Site Survey of Selected Items
for
Compliance with the Americans with Disabilities Act
(ADAAG)
and
Title 24 of the CBC

This report identifies noncompliant items in remodeling and renovation at an existing school site and provides recommended methods for removal of the barriers identified.

The site survey of Walgrove Elementary School was conducted on February 28, 2007 during a spot check for compliance with the Americans with Disabilities Act Guidelines (ADAAG) and Title 24 of the CBC

Facility Name: Walgrove Elementary School

Accessible Parking

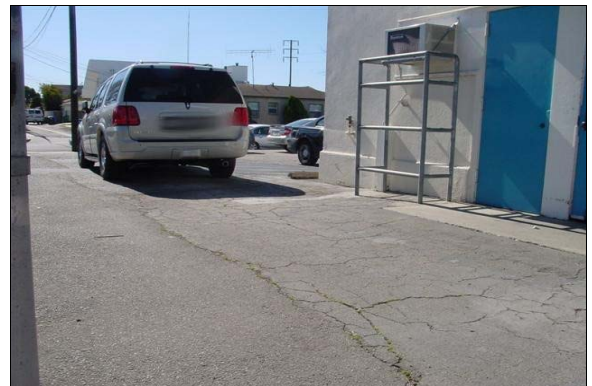
Finding: The parking signage at the standard accessible space contains the word "Handicapped."

Full Rec Install a permanently posted reflectorized sign measuring 70 square inches that includes an ISA symbol adjacent to and visible from the accessible parking space (see CBC 1129B.5). The bottom edge of the sign must be mounted 80 inches from the ground surface so that it cannot be obscured by a parked vehicle (see CBC 1129B.5). Signage shall not contain the word "Handicapped."

Accessible Parking

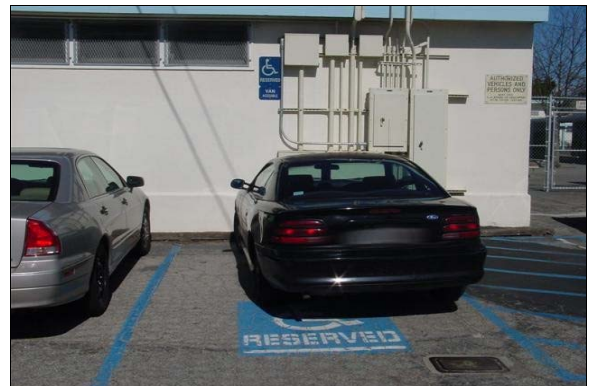
Finding: The location of the accessible parking space requires individuals with disabilities to travel behind parked cars other than their own.

Full Rec Stripe a 48-inch access aisle at the head of the accessible parking spaces and at the general parking spaces. Install a wheelstop at the head of the accessible parking spaces and at the general parking spaces. Wheelstops shall be used to prevent vehicles from encroaching into access aisles or walkways, but shall not present addition encroachment into those areas (see CBC 1129B.4.3).

Boys Restroom Building A

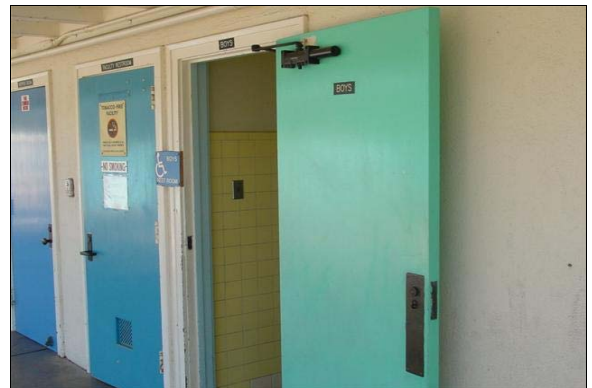
Finding: The bottom 10 inches of the door does not provide a smooth, uninterrupted surface, or panel to allow the door to be opened by a wheelchair footrest without creating a trap or hazardous condition, due to a doorstop.

Full Rec Remove the doorstop from the door to provide a smooth, uninterrupted surface for the bottom 10 inches of the door.

Boys Restroom Building A

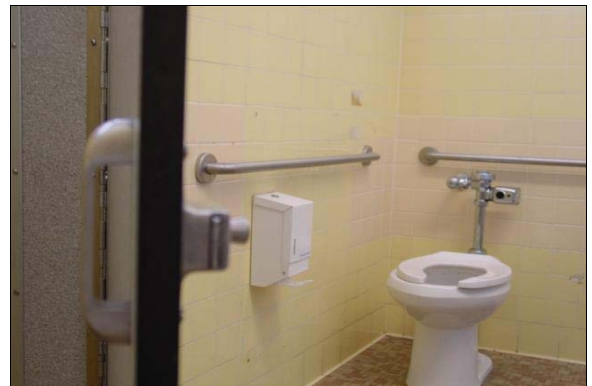
Finding: The door to the stall designated to be accessible in the restroom does not have appropriate accessible hardware.

Full Rec Install a loop or U-shaped handle immediately below the latch hardware on the door to the stall designated to be accessible in the restroom (see CBC 1115B.7.1.3 and ADAAG 4.13.9). Lever-operated or push-type mechanisms may also be used. The latch shall be flip-over style, sliding or other hardware not requiring grasping or twisting.

Girls Restroom Building A

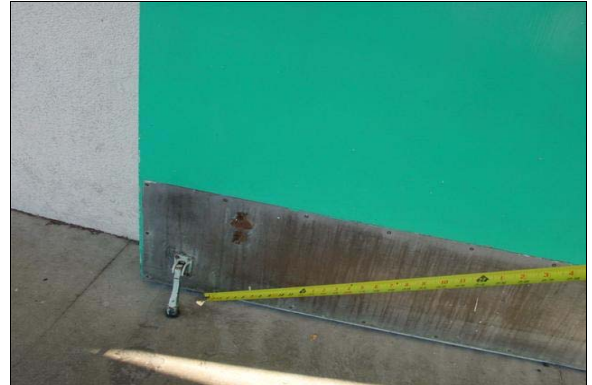
Finding: There is no signage indicating accessibility on the latch side of the entry door of the restroom. There is Title 24 gender use signage on the entrance door.

Full Rec Post signage centered 60 inches above the ground surface on the latch side of the entrance door identifying the restroom as accessible. Signage shall include Braille and raised lettering, the gender or unisex use symbol and the ISA symbol.

Girls Restroom Building A

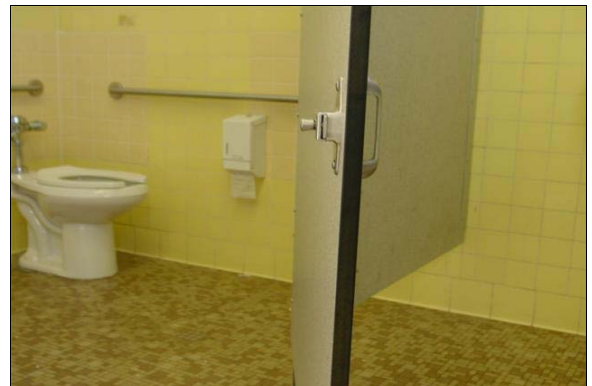
Finding: There is insufficient clear floor space provided in front of the water closet. The door to the stall designated to be accessible in the restroom does not have accessible hardware.

Full Rec Modify or replace the stall designated to be accessible in the restroom so that it complies with ADAAG 4.17.3, CBC 1115B and CBC Figures 11B-1A and 1B. Standard accessible stalls require 60 inches in width with 56 inches depth for wall-mounted toilets or 59 inches depth for floor-mounted toilets to accommodate individuals in wheelchairs. The minimum width of a front-approach doorway shall provide at least 32 inches and a side-approach doorway shall provide at least 34 inches. The door shall swing outward, close automatically and provide accessible hardware.

Girls Restroom Building A

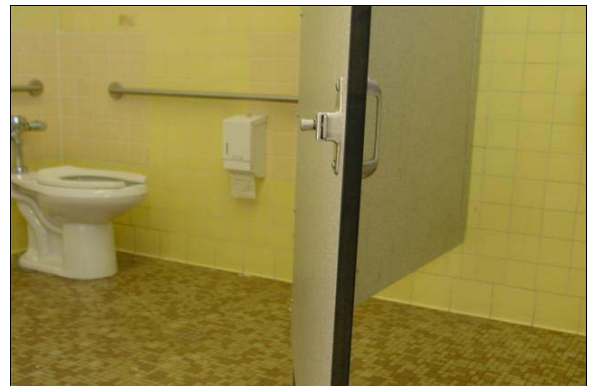
Finding: The height of the toilet seat in the stall designated to be accessible in the restroom is 18 inches above the finished floor.

Full Rec Remove the toilet or modify the height of the toilet seat in the stall designated to be accessible in the restroom to a height of 15 inches above the finished floor to accommodate children ages 5 thru 12 (see ADAAG 4.16.7(2) and ADAAG A4.16.7). Make certain that the toilet seat remains in lowered position.
